Re: 16 Fillmore Avenue

Lot No. 8

Subj: Foundation and Flood Design Review

Re: 16 Fillmore Drive Lot 8

A101

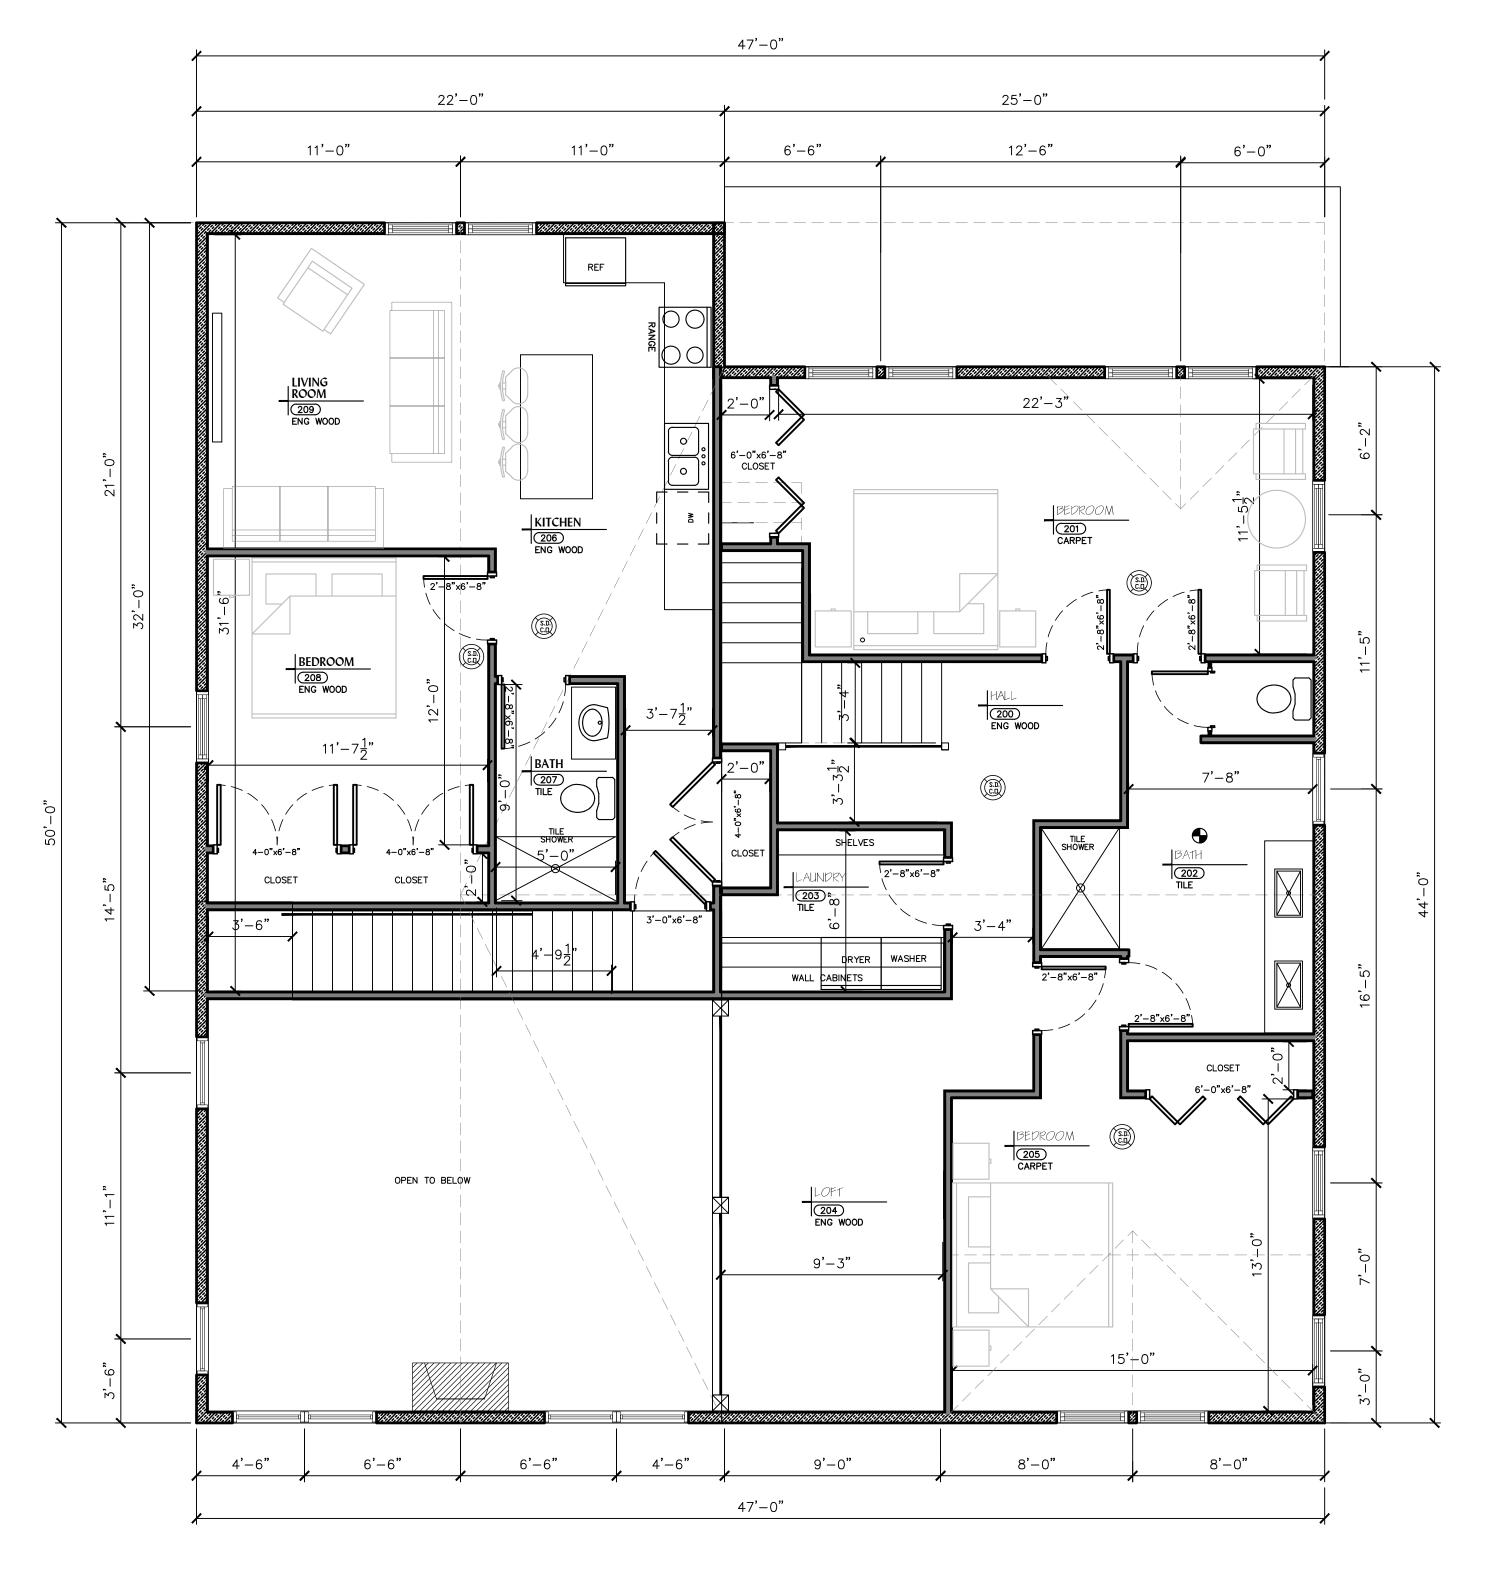
- It is not clear on the drawings exactly which area has been removed from 100 year flood plain. Also, where is the edge of the 100 year flood plain and flood elevation?
- Please confirm and add notes as to the pond high water level.
- What is the framing for the walls at the 2-story living room (Room 105)? Can the studs span two stories or will there be some means to brace the studs at the second floor level? Alternatively, are they pre-engineered lumber studs? Please confirm/verify.

- 5. The high-water level of the pond is 1537.0 and is shown on drawing A301.
- 6. Please note that these drawings are for Site Plan and Architectural review. After the site plan and Architectural review is completed, a construction set of drawings will be submitted to the Village Code Enforcement Officer. The 2-story section will utilize preengineered lumber studs.
